HUNTS POINT INTERSTATE ACCESS IMPROVEMENT PROJECT – CONTRACT 3

PIN X731.65, Contract D900055

Addendum #8

July 22, 2022

TYPICAL EXISTING SECTION 7-7
BENT 143
(LOOKING STA AHEAD)
N.T.S.

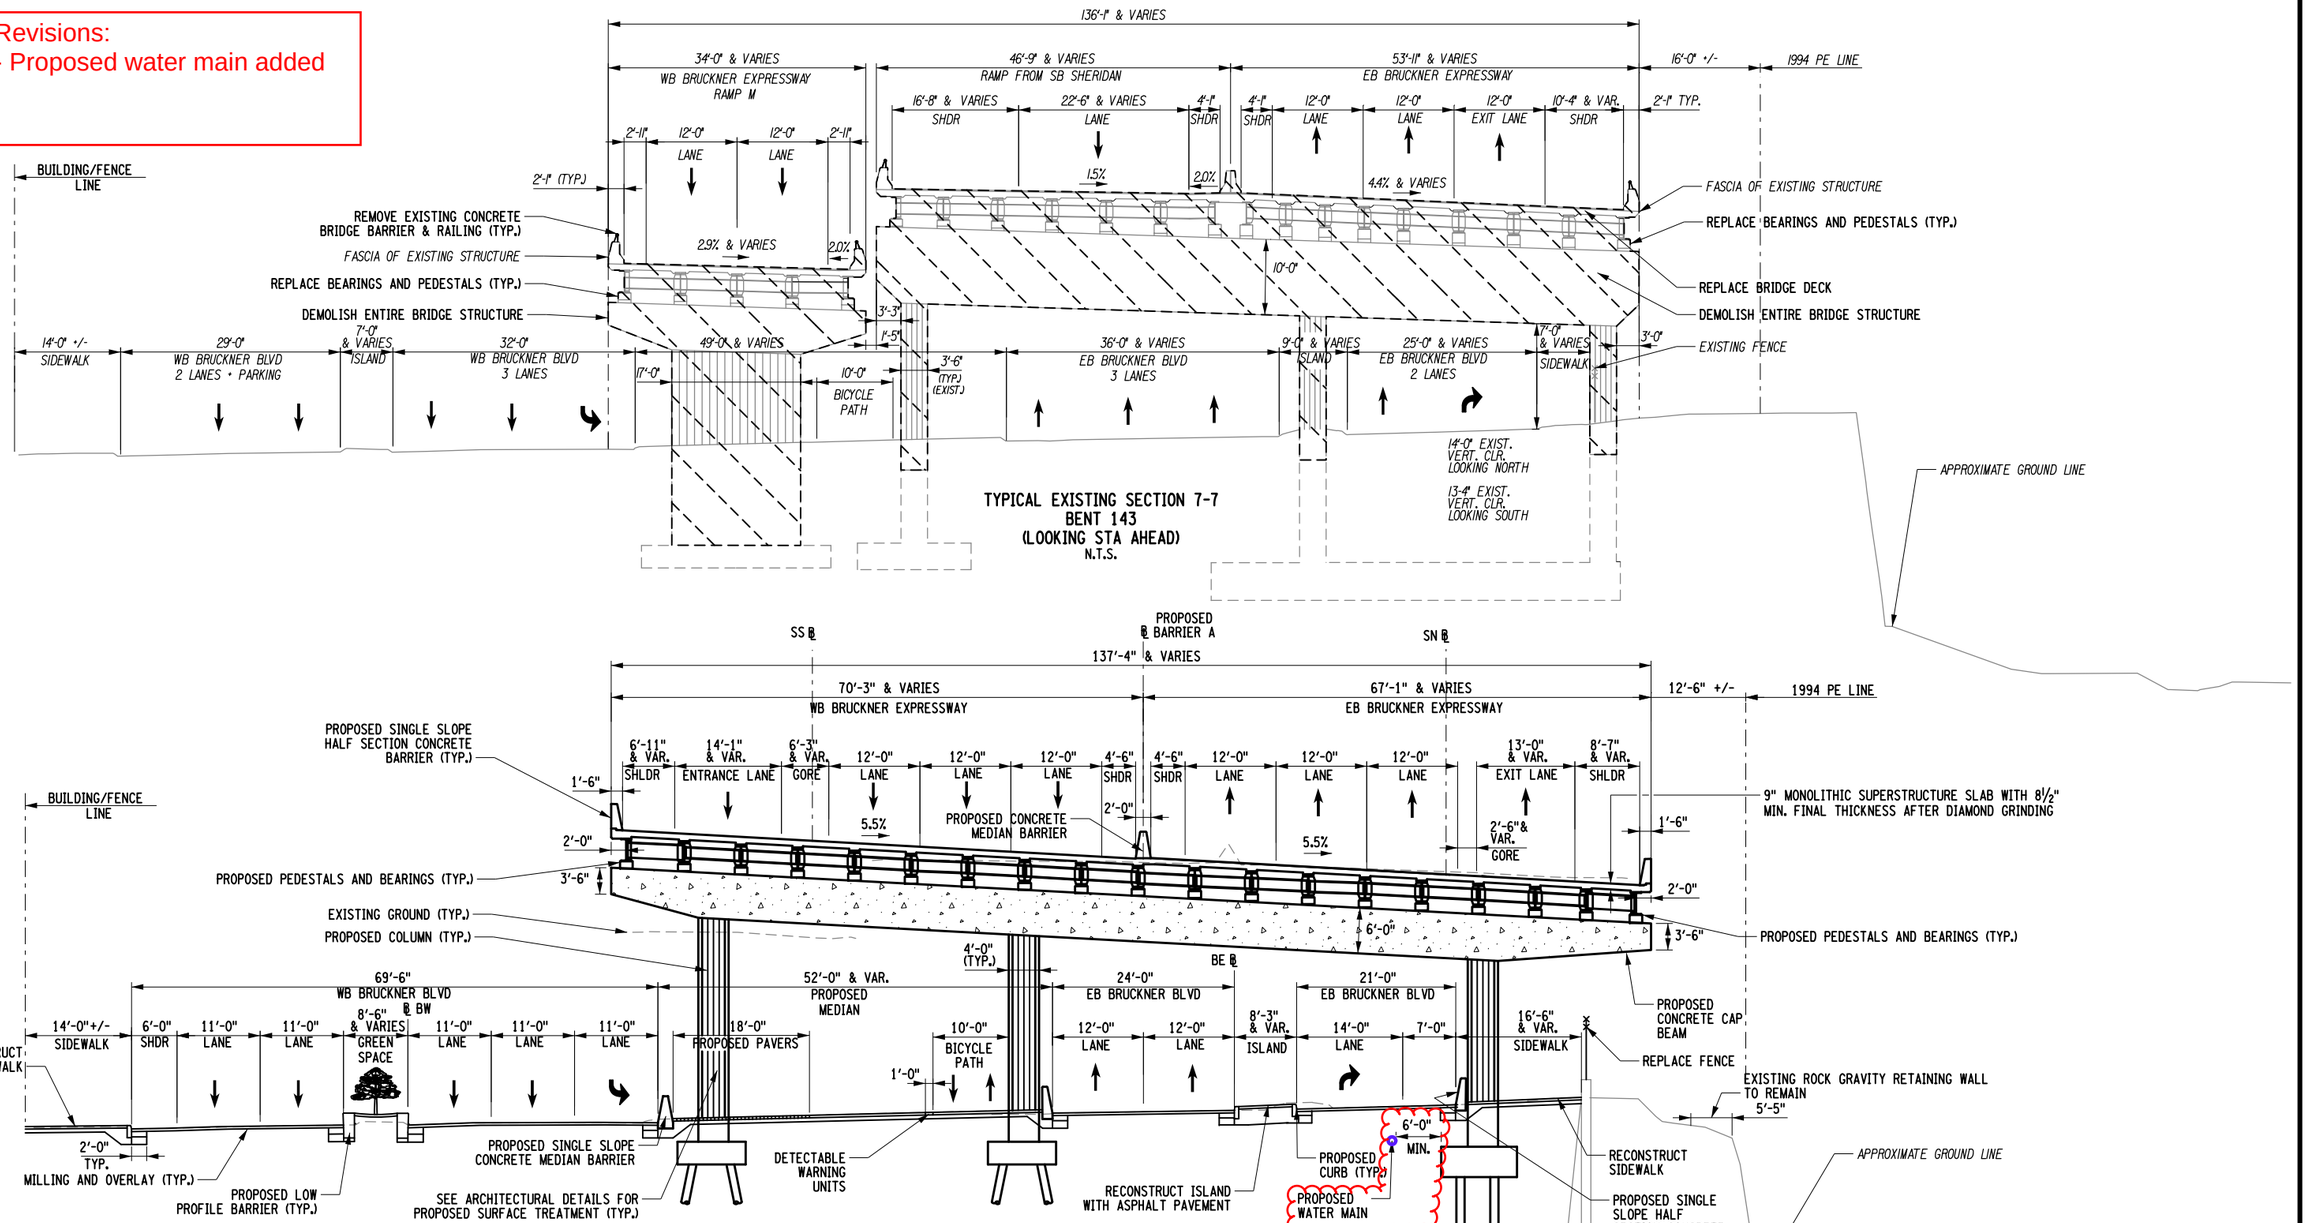
Revisions:
- Proposed water main added

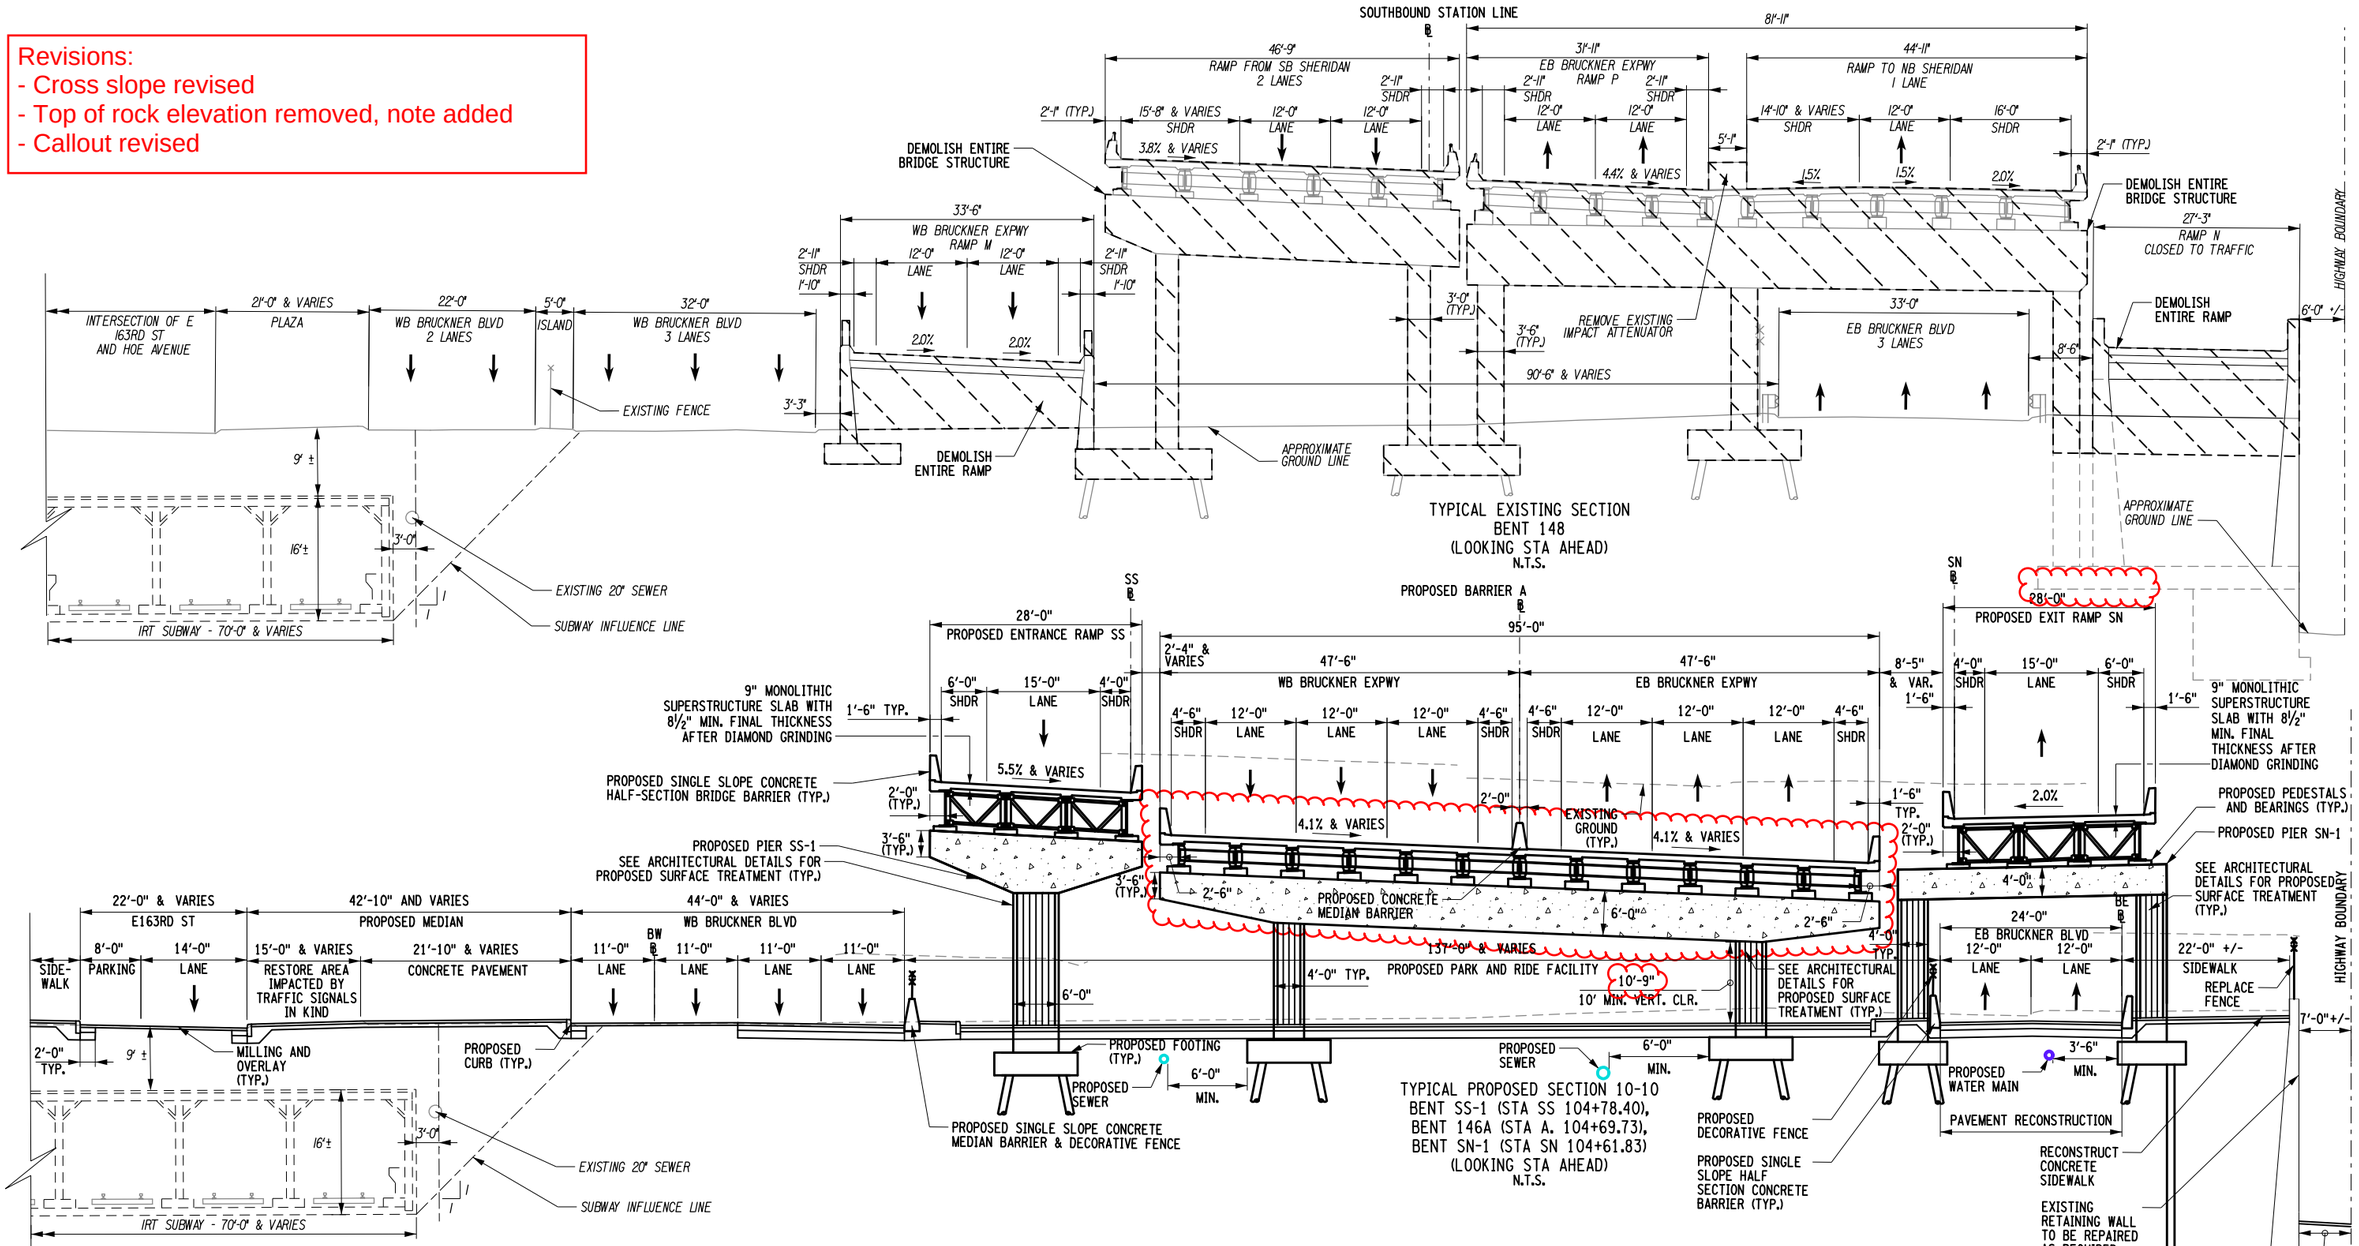
Revisions:
- Cross slope revised
- Top of rock elevation removed, note added
- Callout revised

NOTES:
1. FOR TOP OF ROCK ELEVATIONS, SEE GEOTECHNICAL DATA REPORT.

TYPICAL EXISTING SECTION
FROM PROPOSED ABUTMENT TO BENT 153
BENT 150 SHOWN
(LOOKING STA AHEAD)
N.T.S.

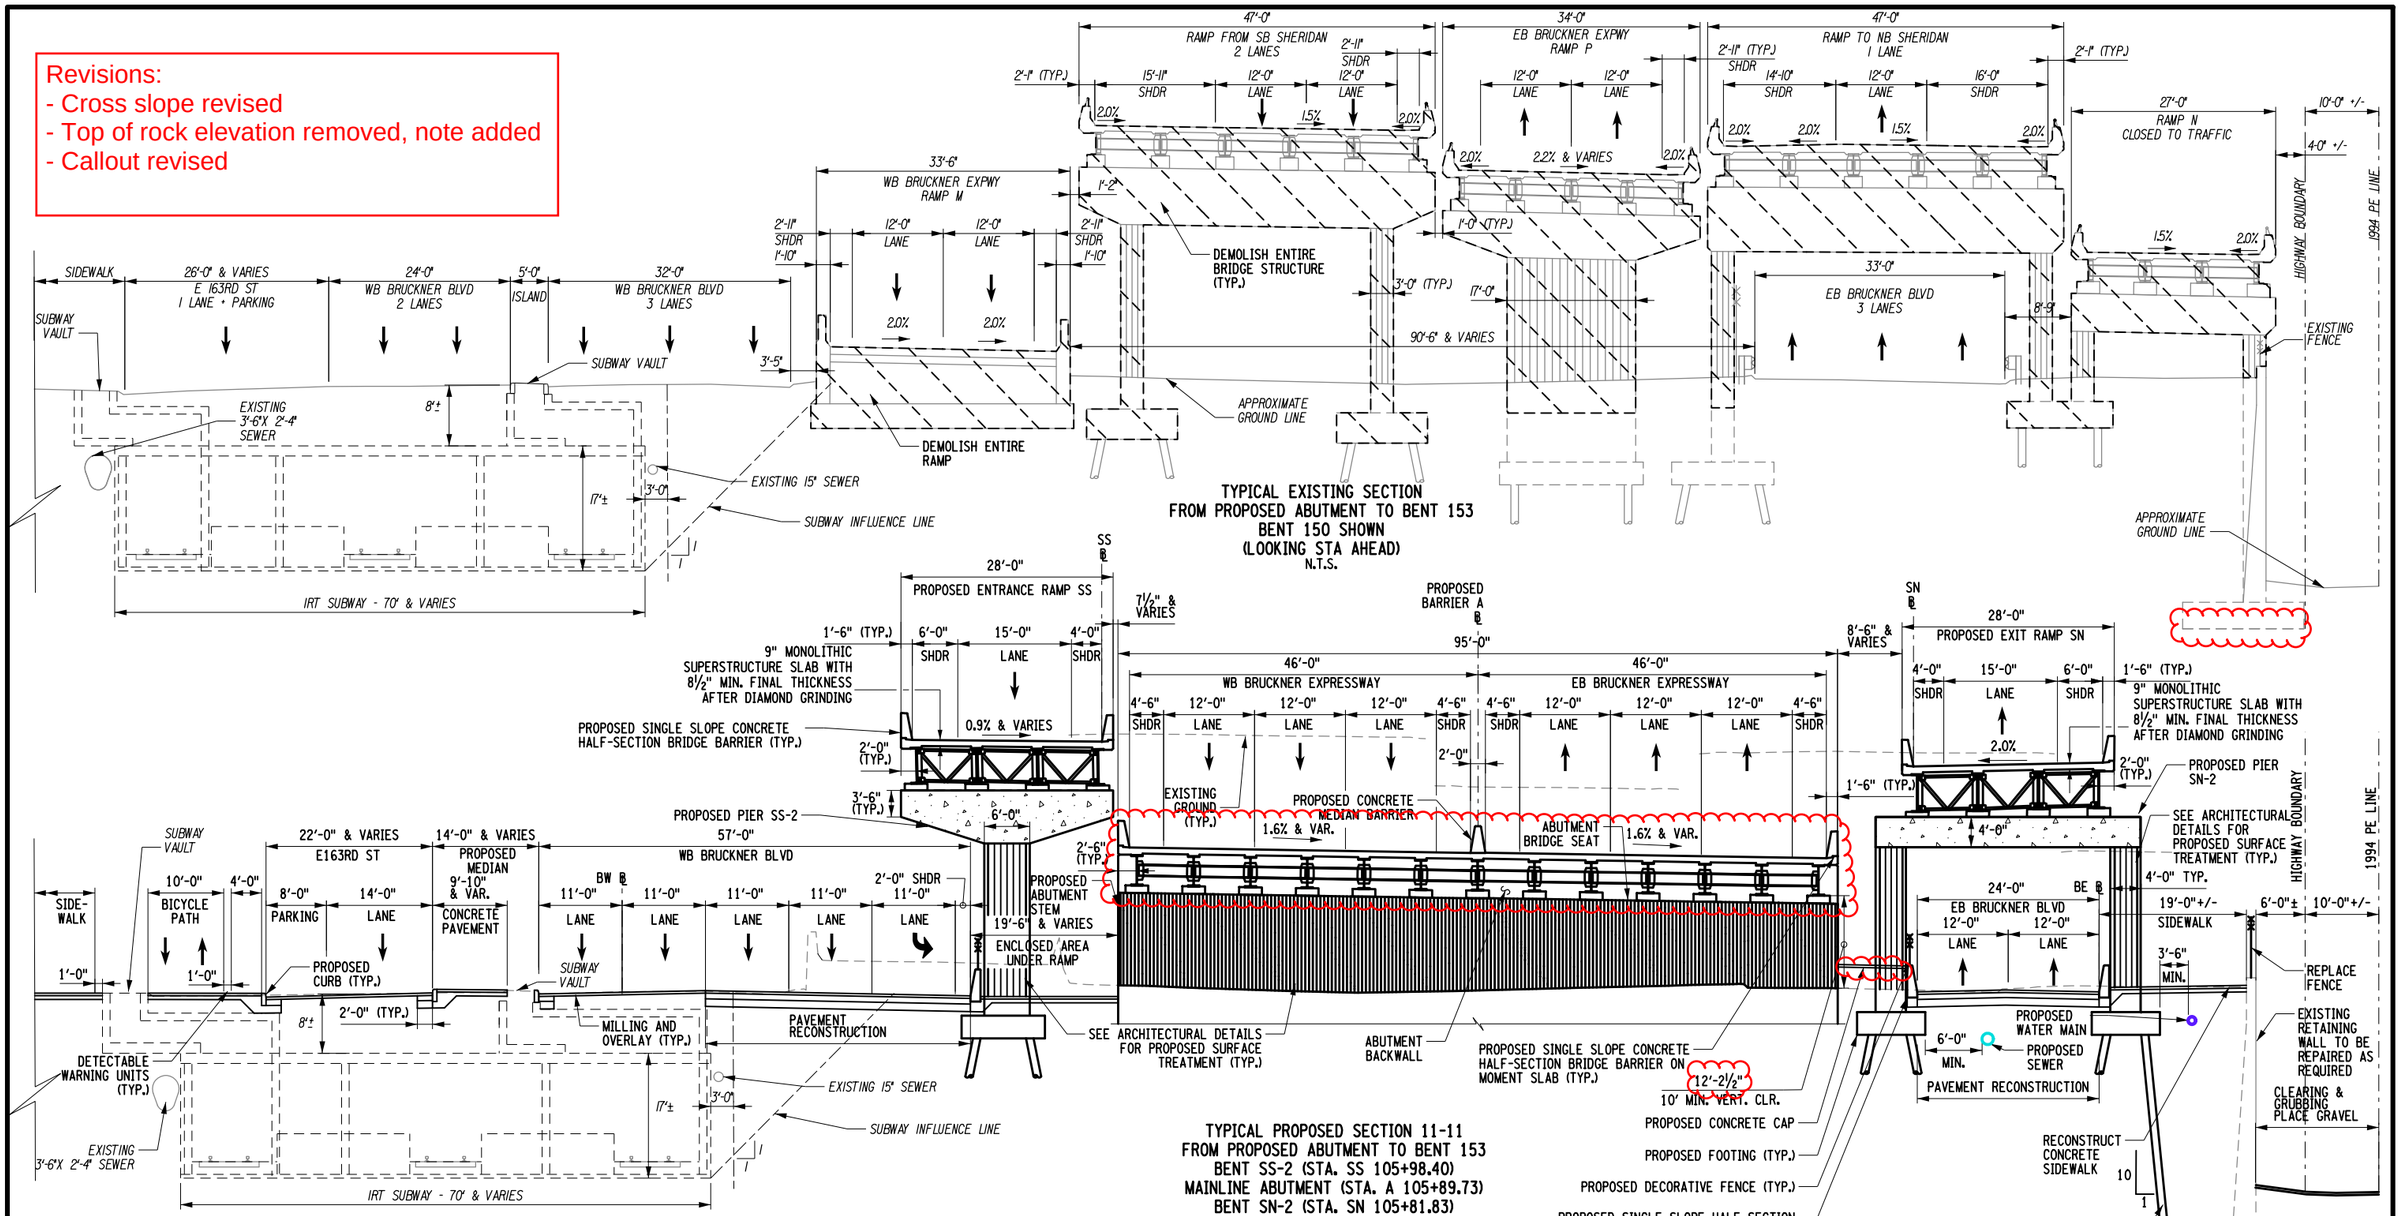
Revisions:
- Cross slope revised
- Top of rock elevation removed, note added
- Callout revised
